RALPH G. MASTROMONACO, P.E., P.C.

Re: Village Square Residences and Commercial Development
3095 Albany Post Road
Village of Buchanan, NY

We received comments from James J. Hahn Engineering, PC dated August 18, 2023 and offer the following information:

Figure: Analysis 100 Year Storm - Basin with Start Elevation 84.1 feet showing a reduction in peak flows.

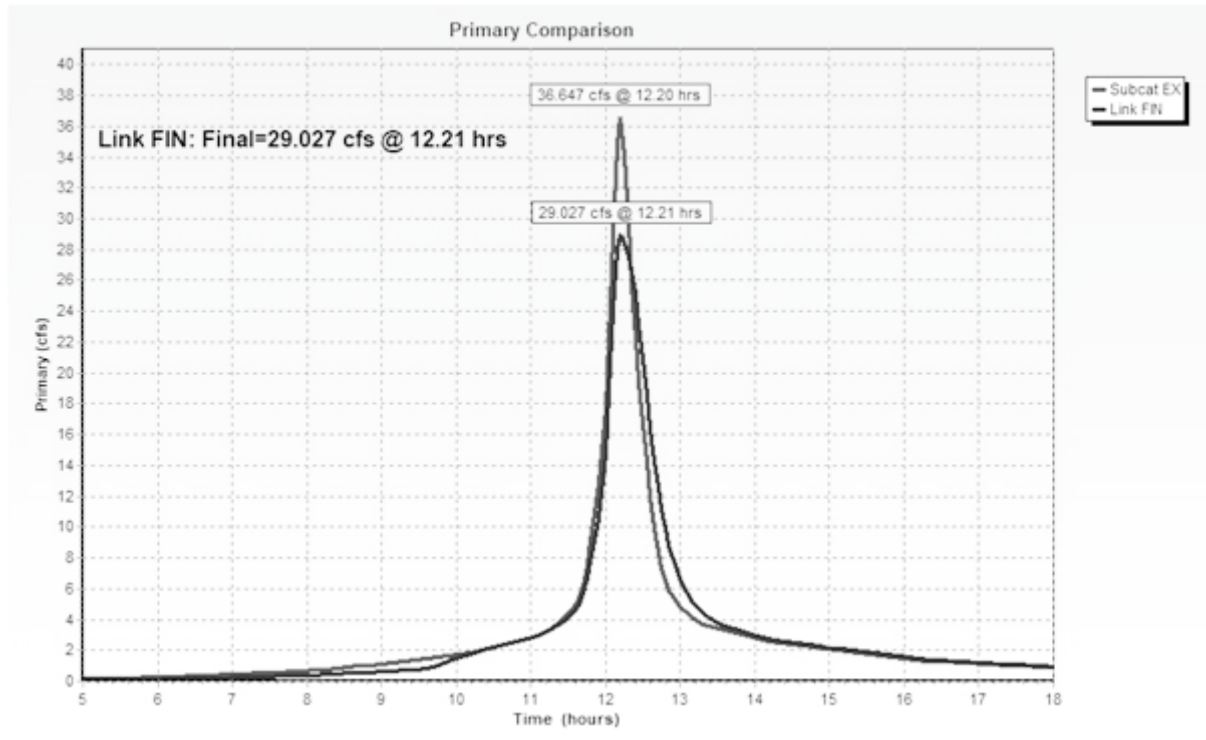
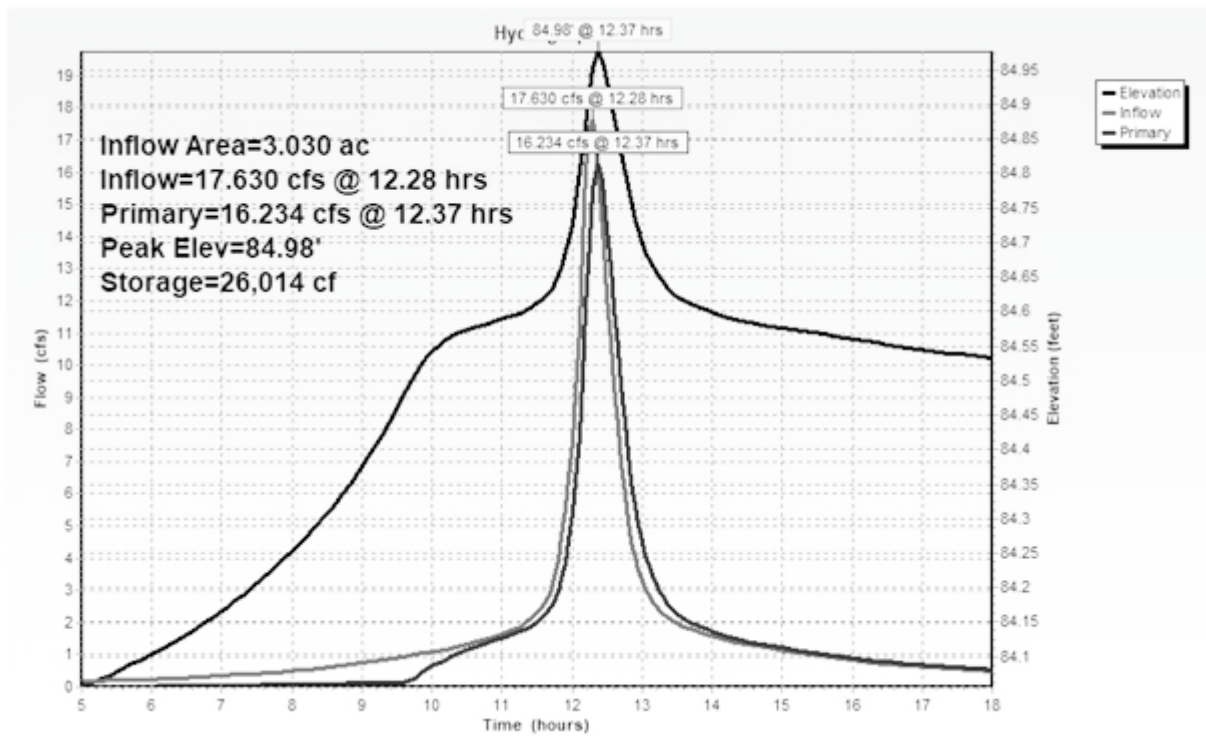
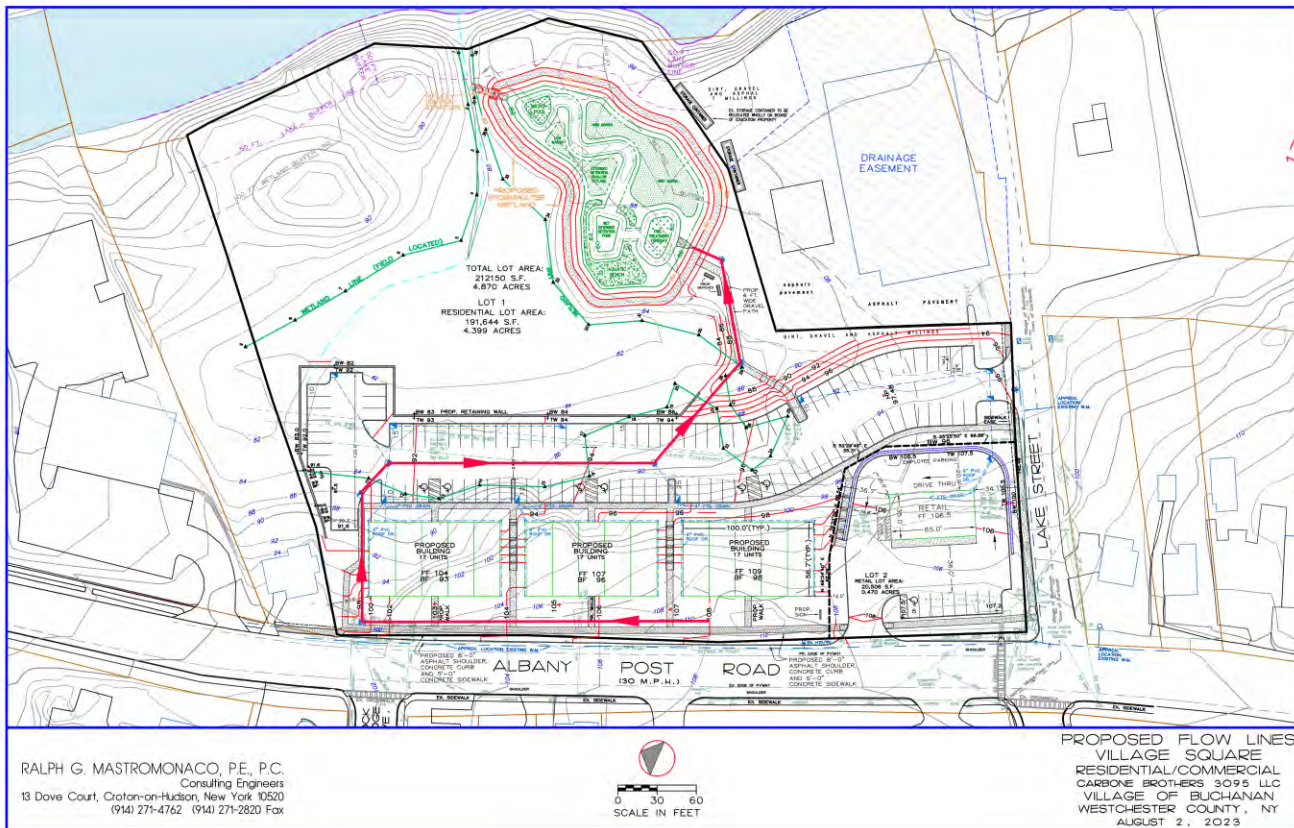
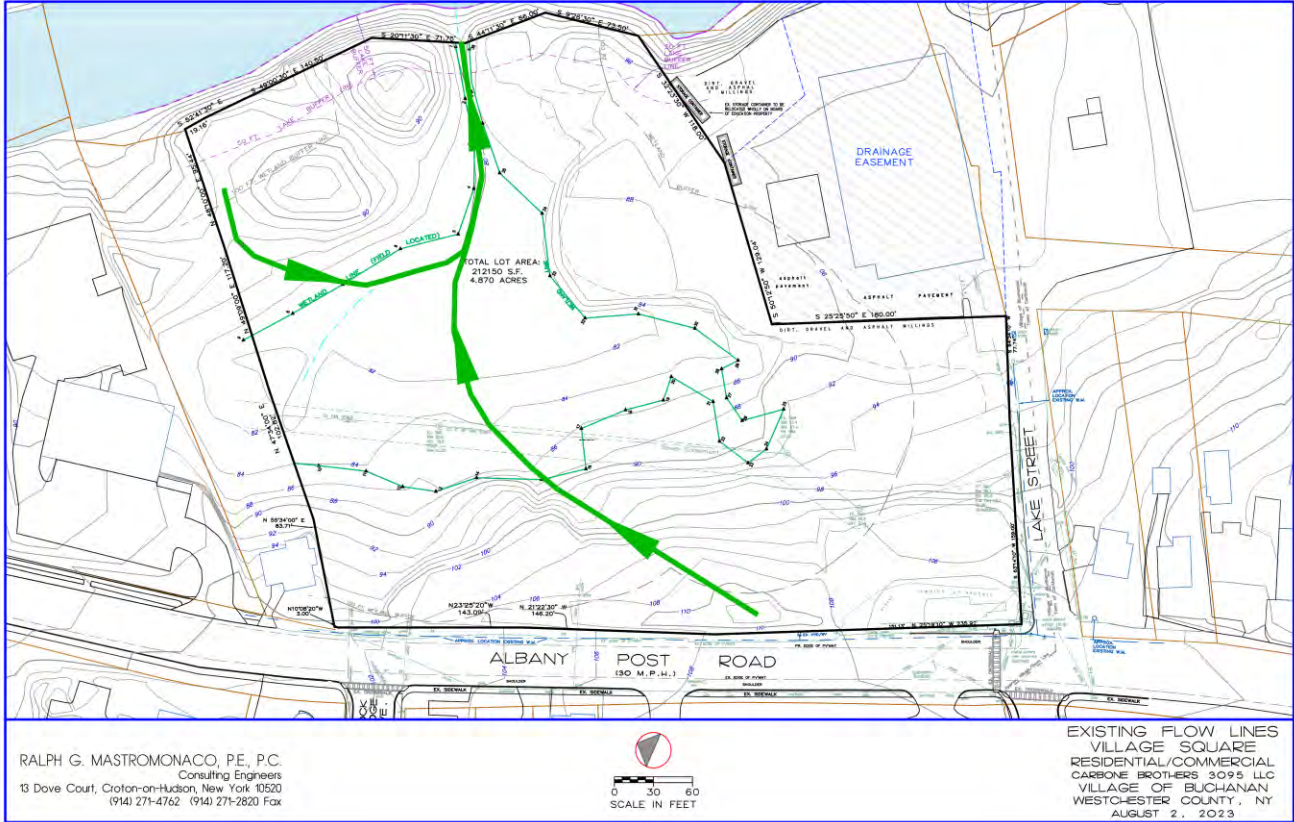
24. An emergency condition analysis utilizing no wetland storage or low flow orifices should be provided to demonstrate that in the event of failure or no maintenance, the 100-year storm can safely pass over the high-level overflow with adequate freeboard provided.

Response: An analysis was provided and we enclose two exhibits that examine the issue raised by the Village Engineer.

Figure: Analysis 100 Year Storm - Peak Elevation of 84.98 feet with Start elevation at 84.1 feet (The basin top elevation is 86.0 ft. – therefore there would be about 1 foot of freeboard provided in this case)

In regard to emergency events, the figures indicate proper operation of the stormwater basin even with a starting elevation of 84.1 feet being the low level outlet elevation.

SITE PLAN/
PRELIMINARY PLAT
VILLAGE OF BUCHANAN
RESIDENTIAL/COMMERCIAL
CARBONE BROTHERS 3095 LLC
VILLAGE OF BUCHANAN
WESTCHESTER COUNTY, NY
NOVEMBER 23, 2022
SHEET 1 OF 8 SHEETS

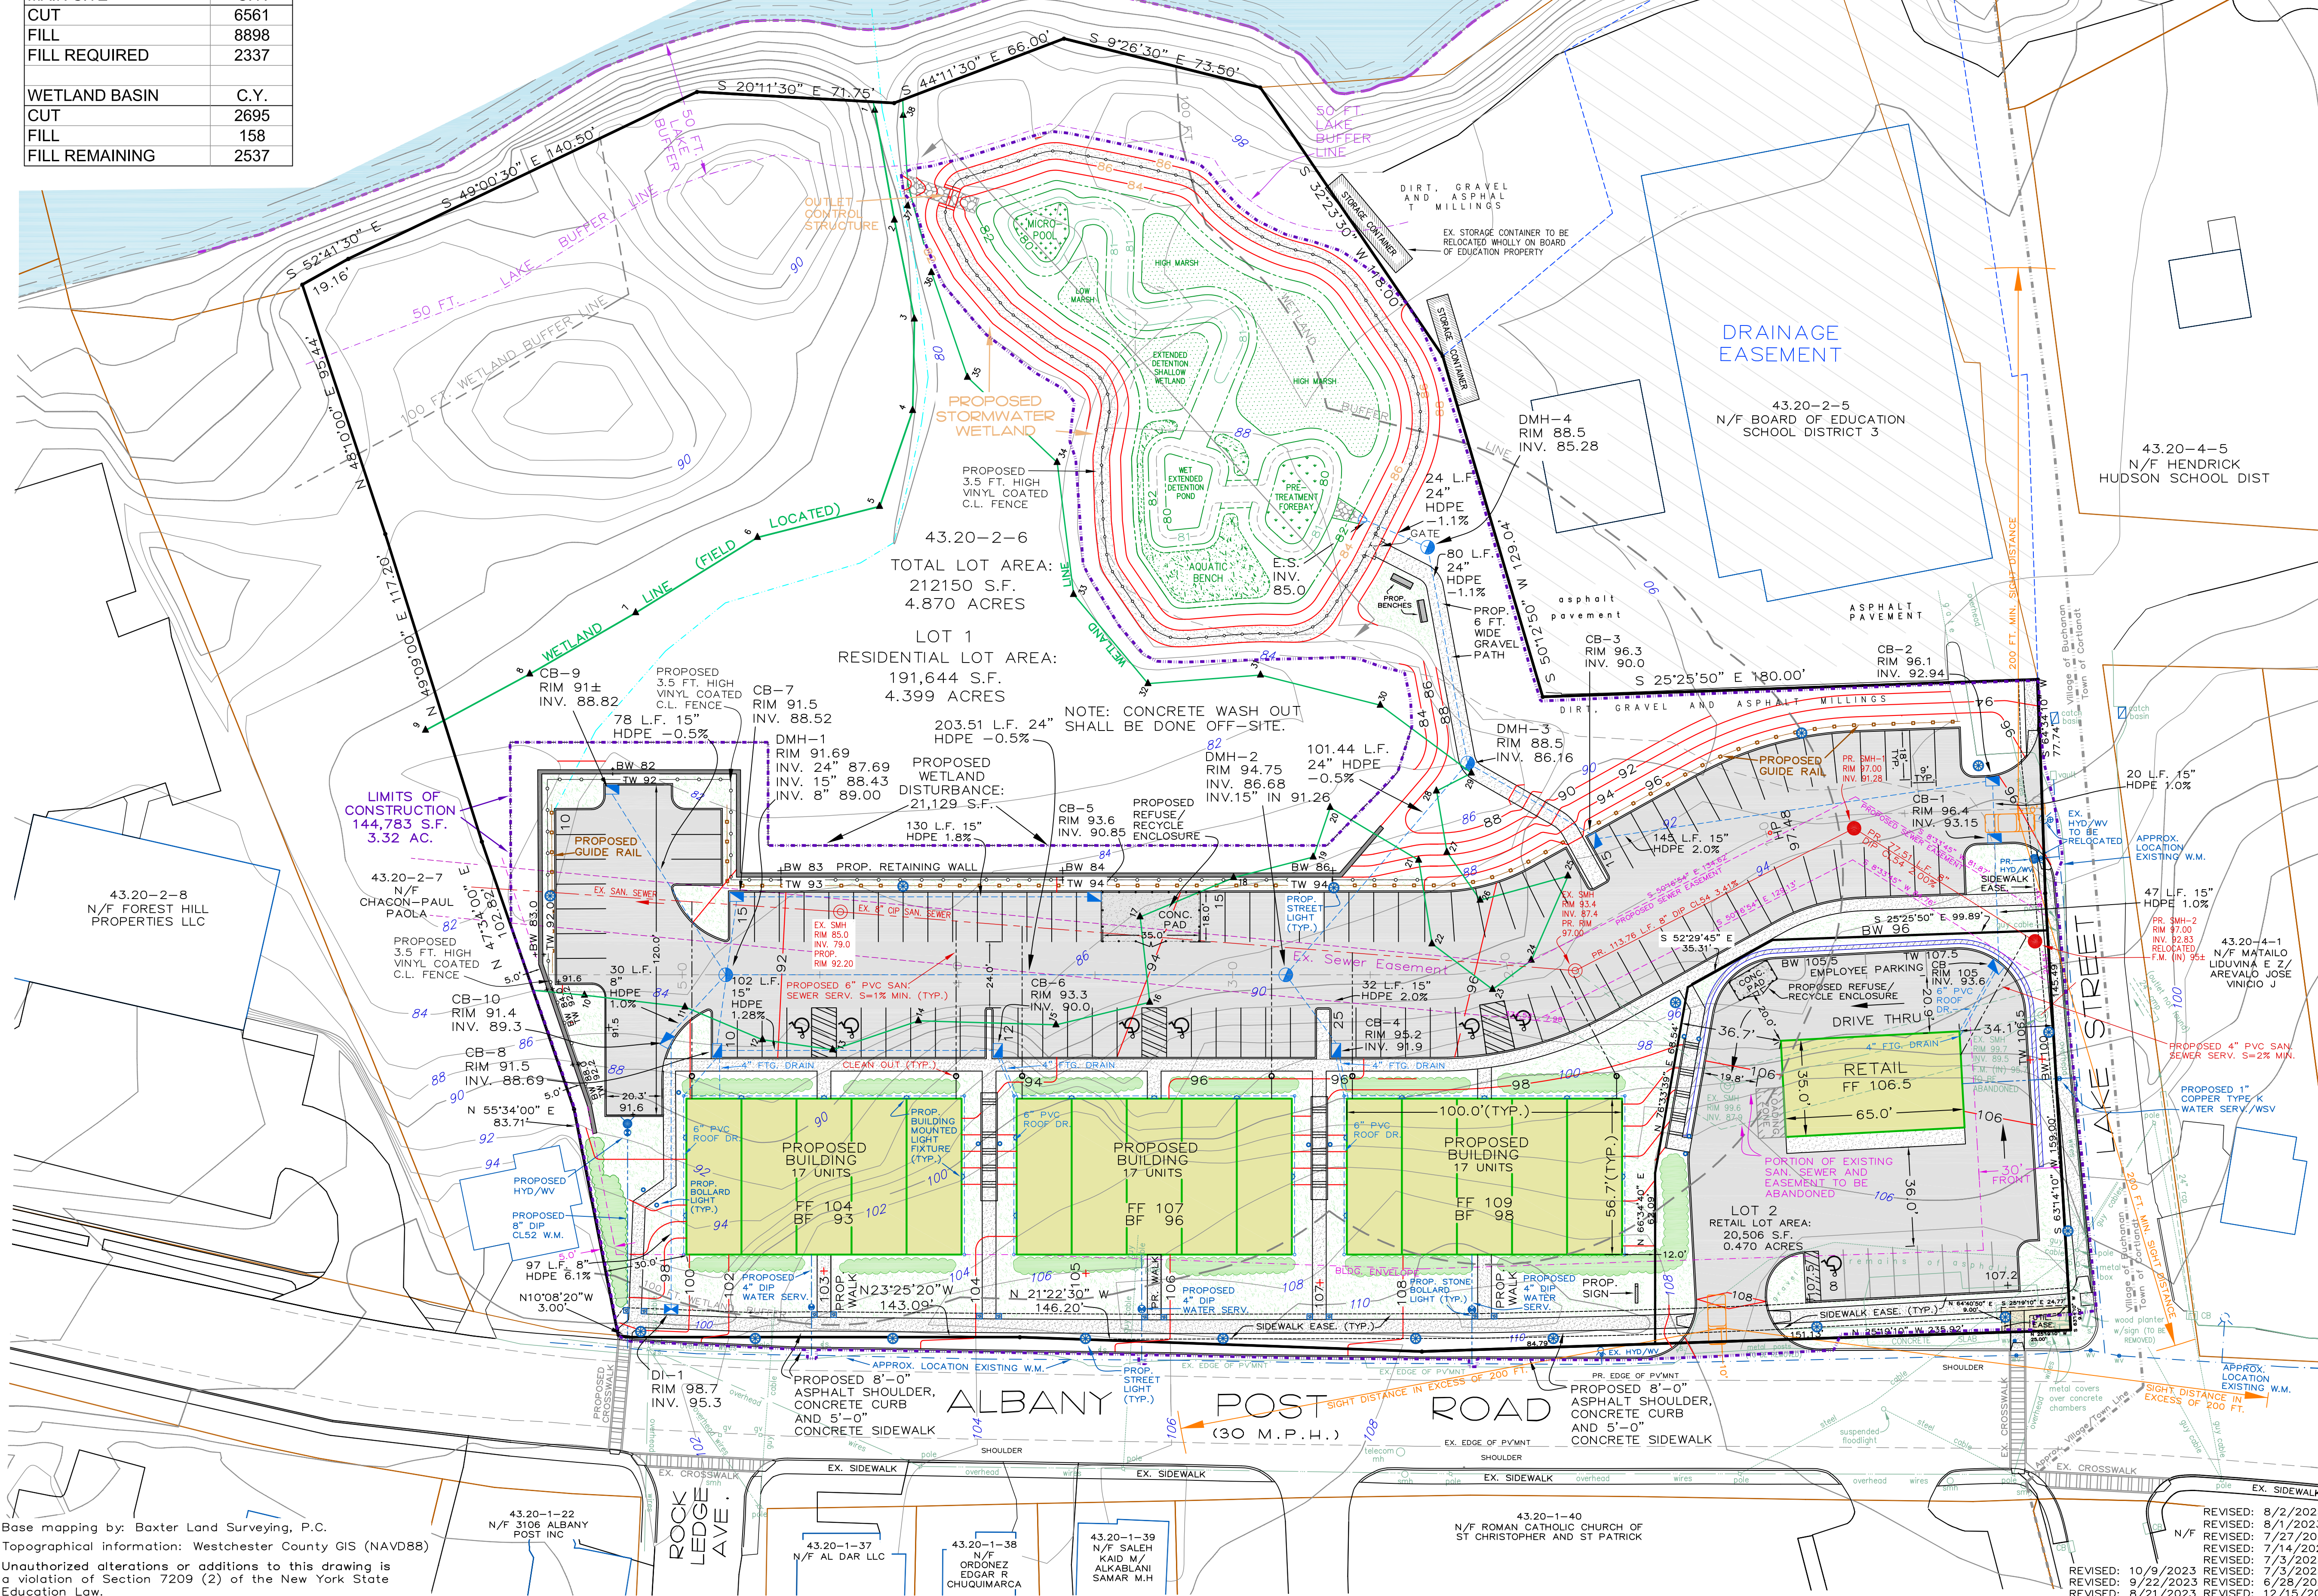
36. As shown in the table on the Site Plan, it is unclear how the wetland buffer area and disturbance to the buffer area has decreased from the previous plan. This should be explained.

Response: Earlier wetland buffer was off by 85 square feet since one wetland flag was left off the series. The current plans have the corrected areas.

SEWER PROFILE
 SCALE: HOR. 1"=20'
 VER. 1"=4'

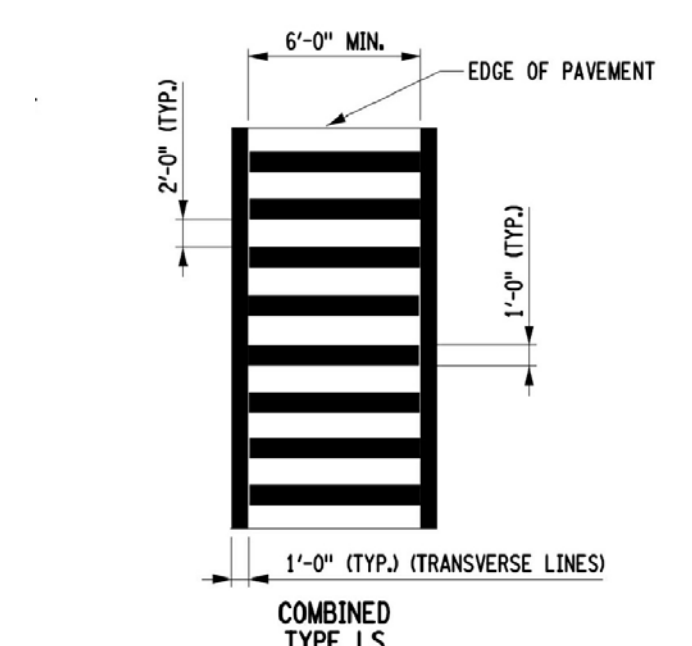
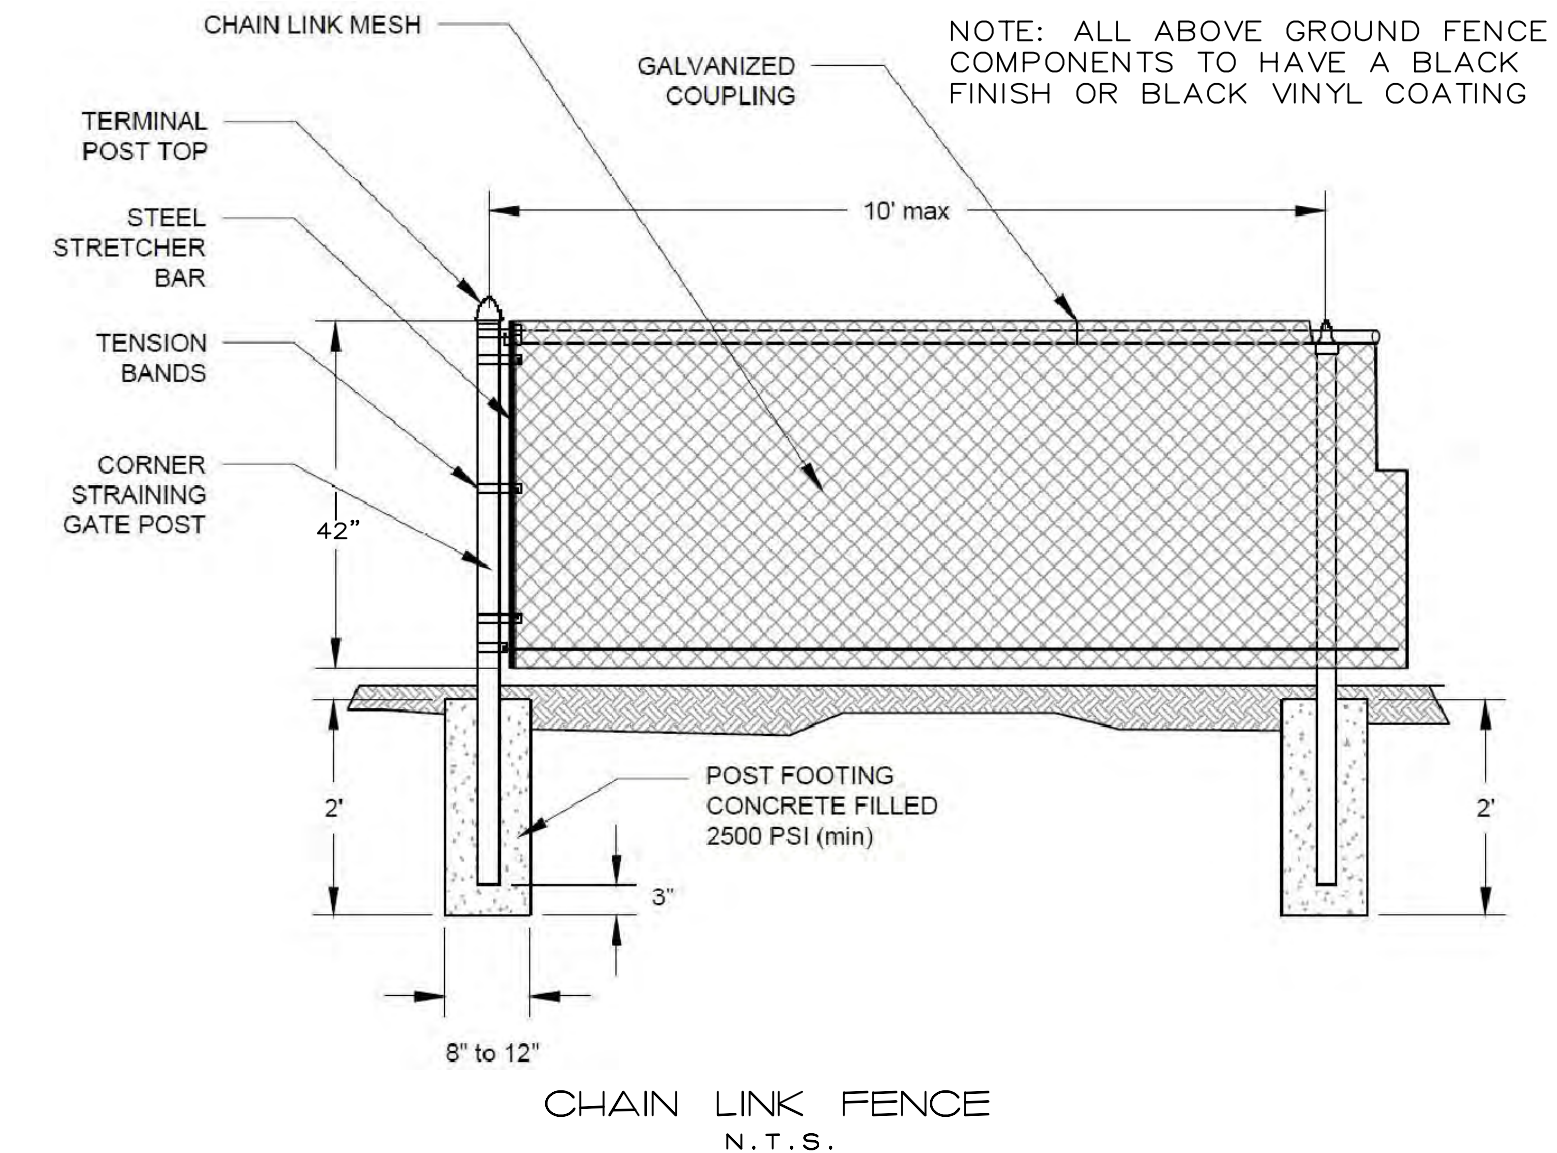
32. Proposed sewer connections and pipe crossings should be shown on the sewer profile.

Response: Sewer connections and pipe crossings have been added to the Profile.
